**City of Rancho Cucamonga
El Camino Project
Final Environmental Impact Report
(State Clearinghouse # 2023080369)**

September 16, 2025

2.0 RESPONSE TO COMMENTS

H15

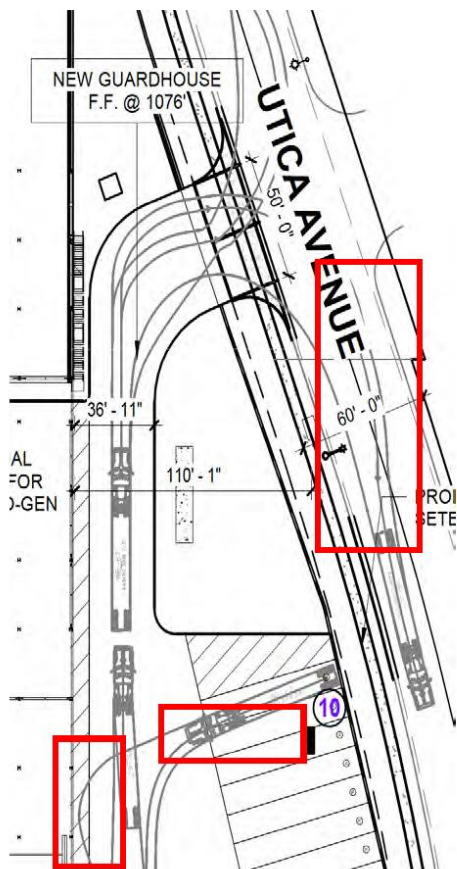
Further, the EIR has underreported the quantity VMT generated by the proposed project operations. The operational nature of industrial/warehouse uses involves high rates of truck/trailer/delivery van VMT. Once employees arrive at work at the proposed project, they will conduct their jobs by driving trucks/trailers/delivery vans across the region as part of the daily operations as a Distribution Center and ASRS, which will drastically increase project-generated VMT. The project’s truck/trailer and delivery van activity is unable to utilize public transit or active transportation and it is misleading to the public and decision makers to exclude this activity from VMT analysis. The project’s total operational VMT generated is further inconsistent with the significance threshold and legislative intent of SB 743 to reduce greenhouse gas emissions by reducing VMT. A revised EIR must be prepared to reflect a quantified VMT analysis that includes all truck/trailer and delivery van activity.

H17

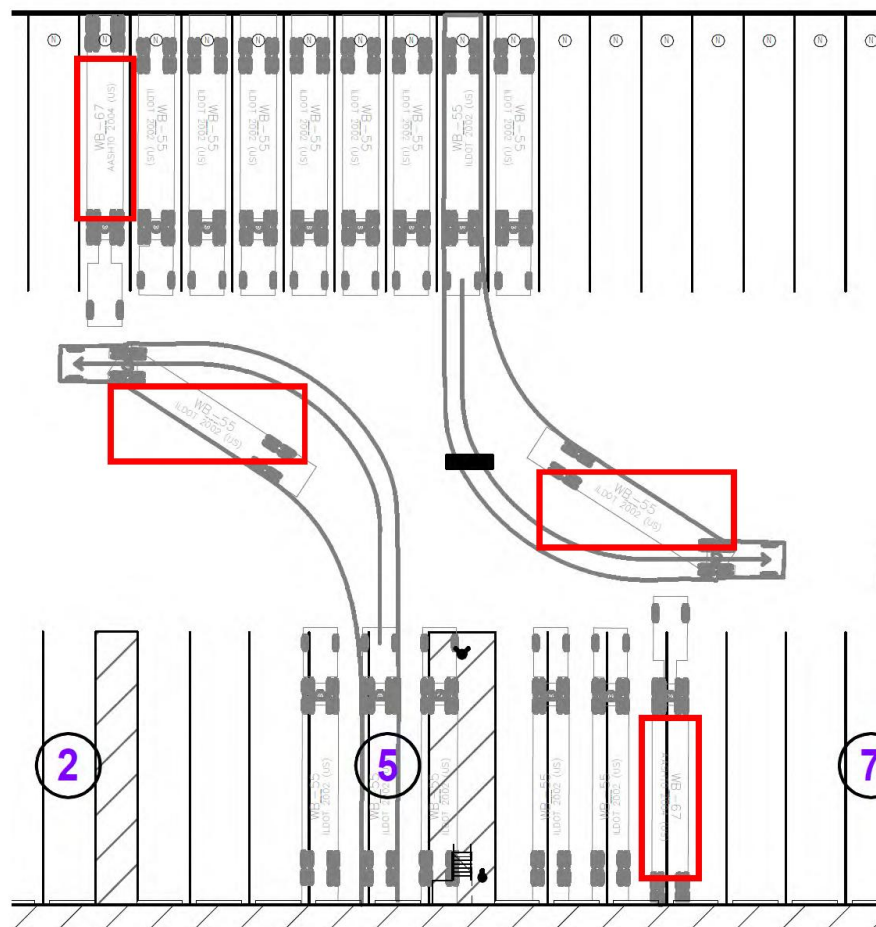
Further, the design and layout of the truck/trailer loading dock court and parking stalls on the north side of the predict site cannot accommodate truck/trailer maneuvering. The exhibit avoids modeling a WB-67 truck (a standard 72 feet in length) maneuvering at the loading dock while another WB-67 truck is parked at the adjacent parking stalls. The exhibit only models a WB-55 (shorter truck) maneuvering at the loading dock while a WB-67 is parked in the parking stall, and vice versa, in order to avoid depicting that the site cannot accommodate maneuvering of multiple WB-67 trucks.
